VALUE ENGINEERING WORKSHOP

BUFORD HIGHWAY AND PLEASANT HILL ROAD

Gwinnett County, Georgia

19 August 2004

PROPOSAL NUMBER:	SB-3.1
PAGE NUMBER:	4 of 6

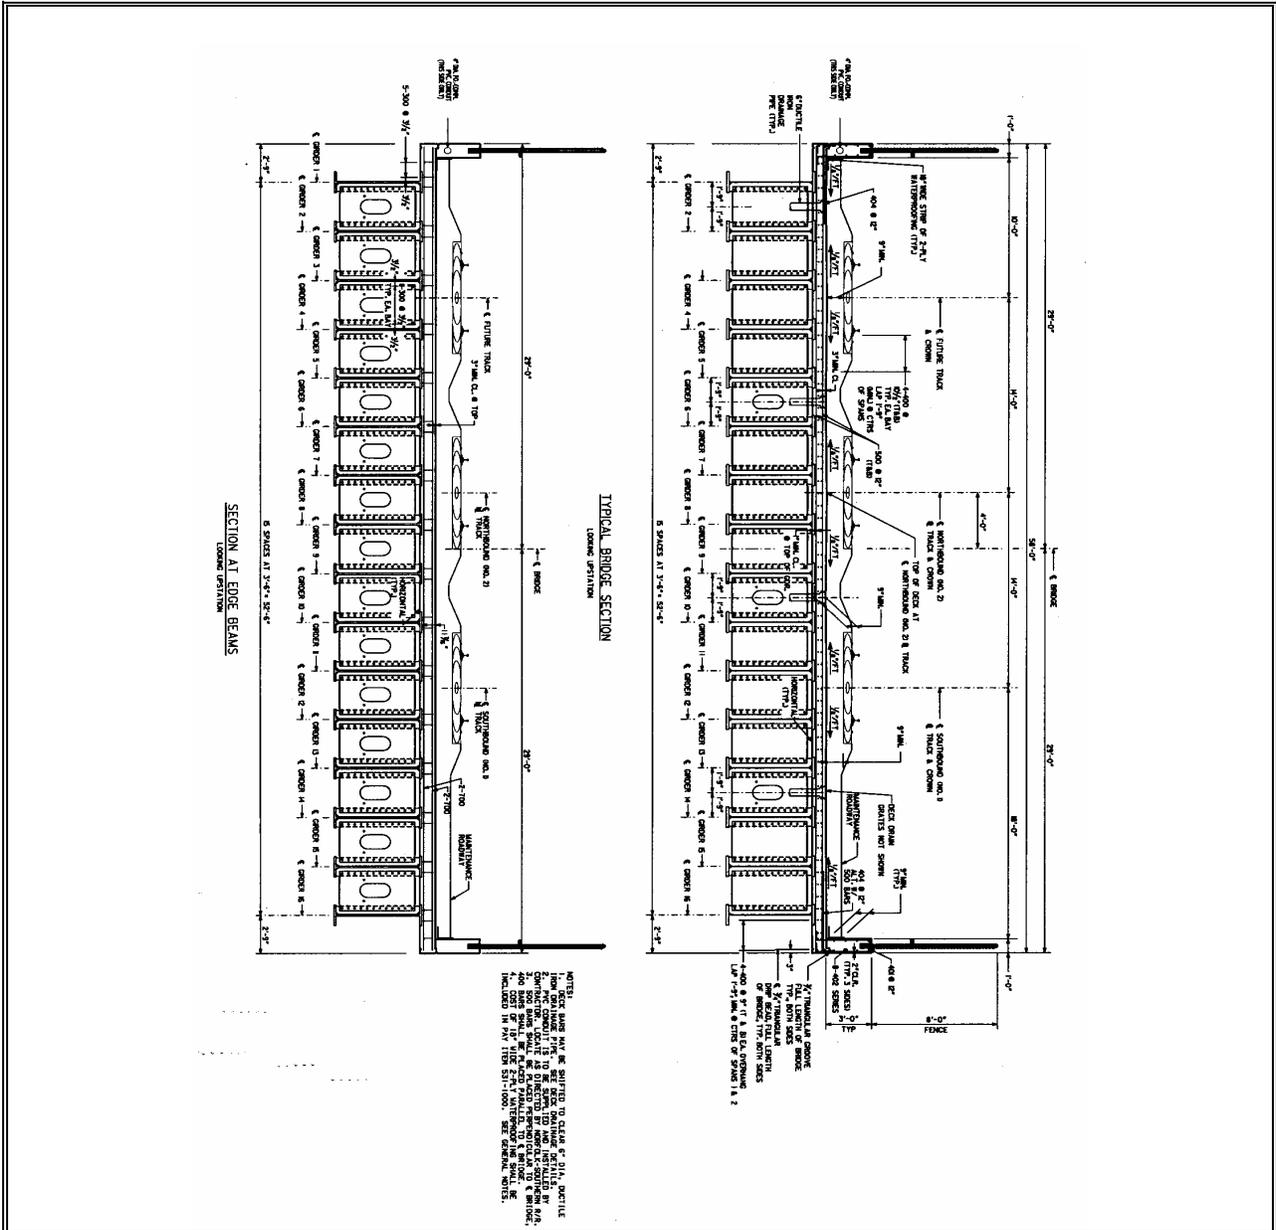
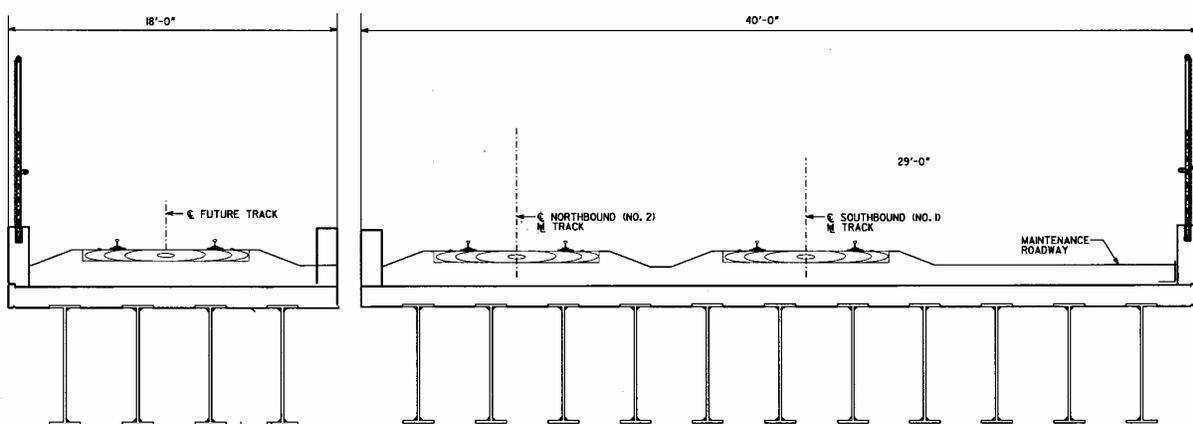
PROPOSED CHANGE: The proposed design recommends the construction of a two-track bridge with 39'-0" wide and enough room for the construction of a single bridge for the third track in the future. If needed.

PROPOSAL NUMBER:	SB-4.0
PAGE NUMBER:	4 of 6

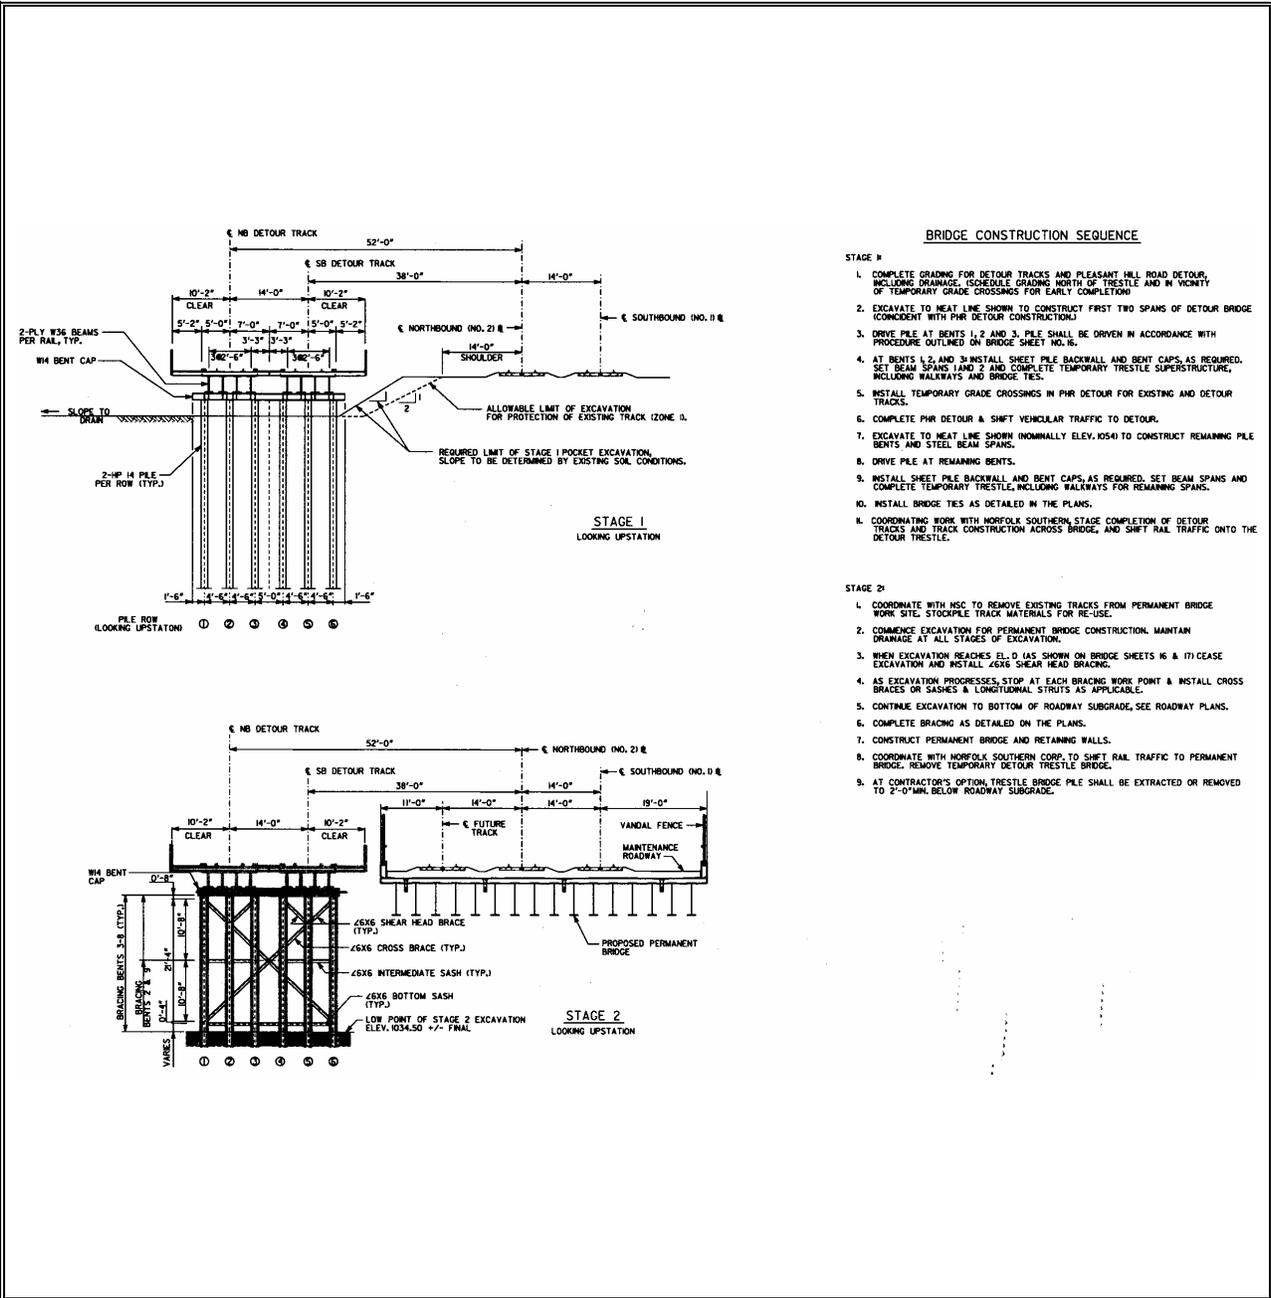
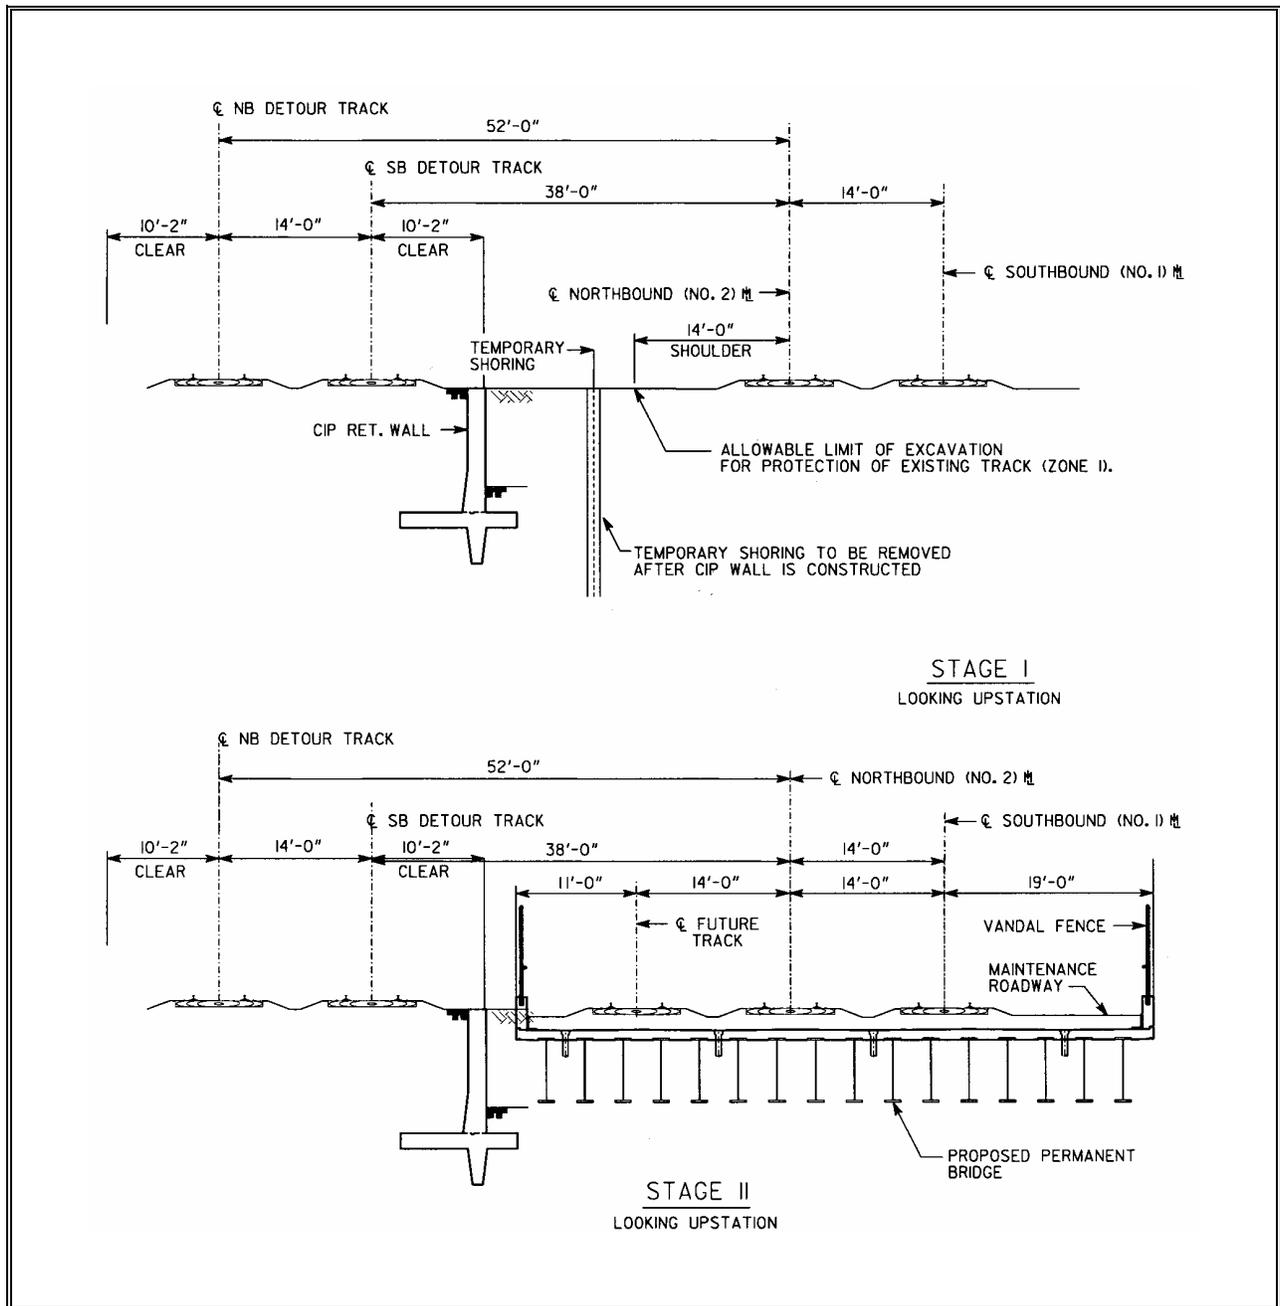
PROPOSED CHANGE: The proposed design proposes the utilization of shoring and retaining walls that is offset a 26'-0" minimum distance from the existing NB track mainline

PROPOSAL NUMBER:	SB-7.0
PAGE NUMBER:	4 of 6

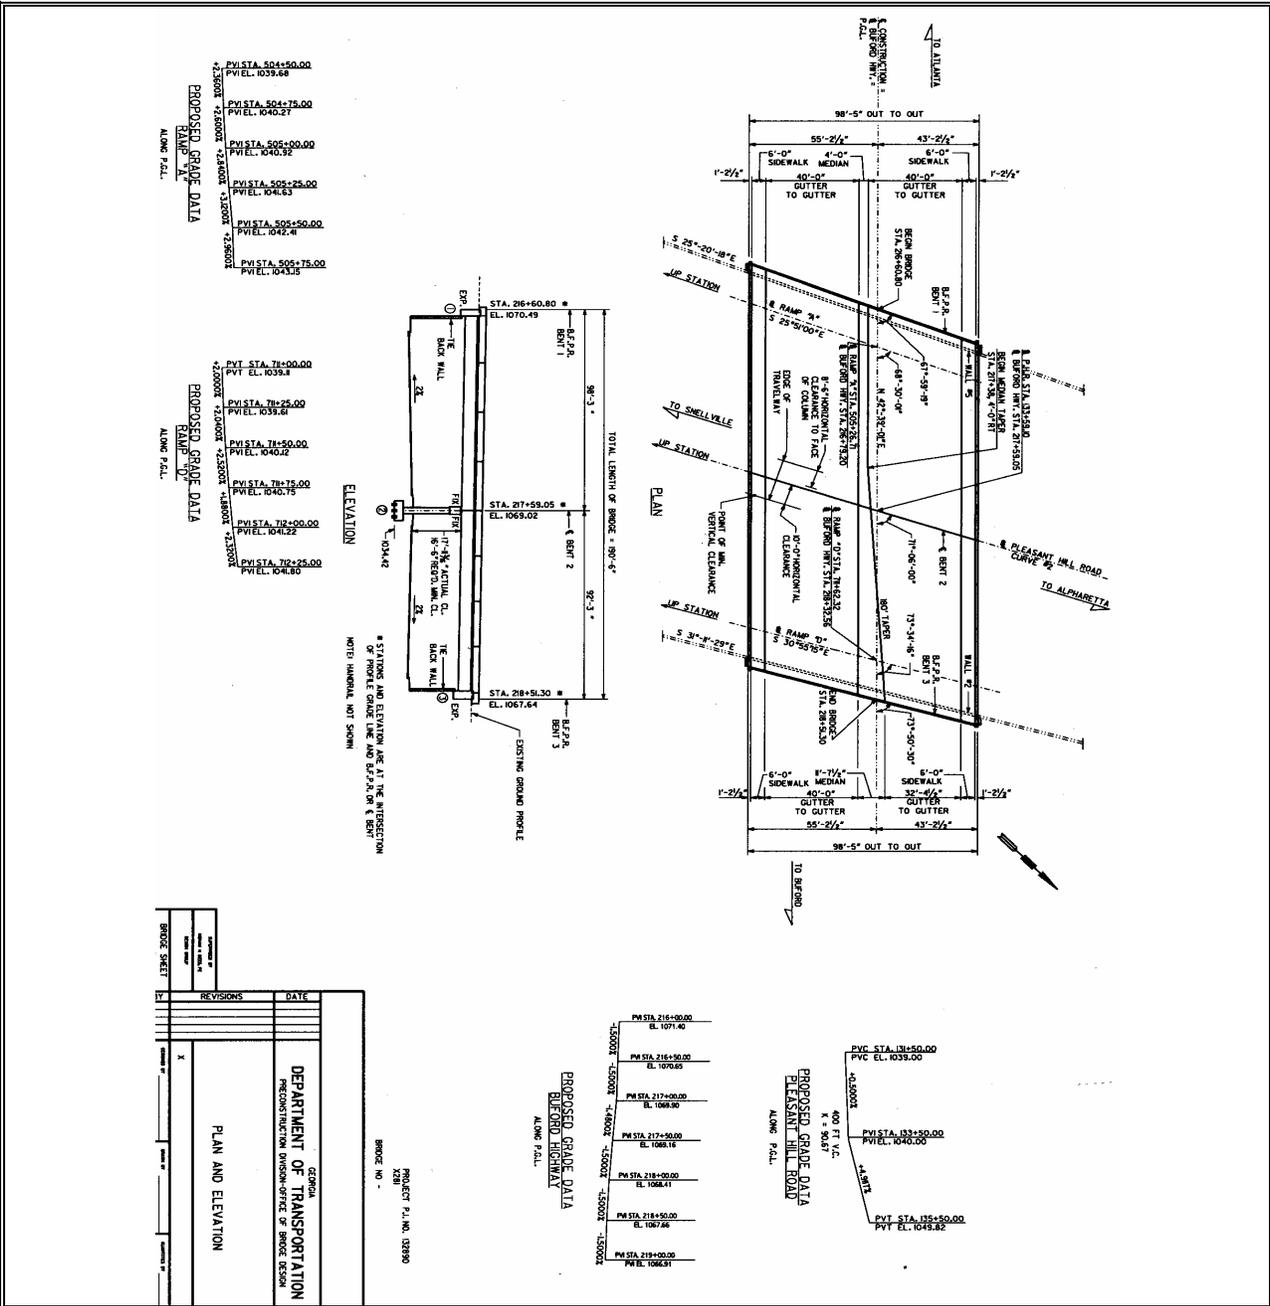
PROPOSED CHANGE: The proposed design recommends the utilization parallel bents to the centerline intermediate bent with end bents of variable offsets to tie back wall thereby eliminating the various beam lengths.

Fabrication and labeling process is simplified as well as the shop drawing review stage is much simpler.
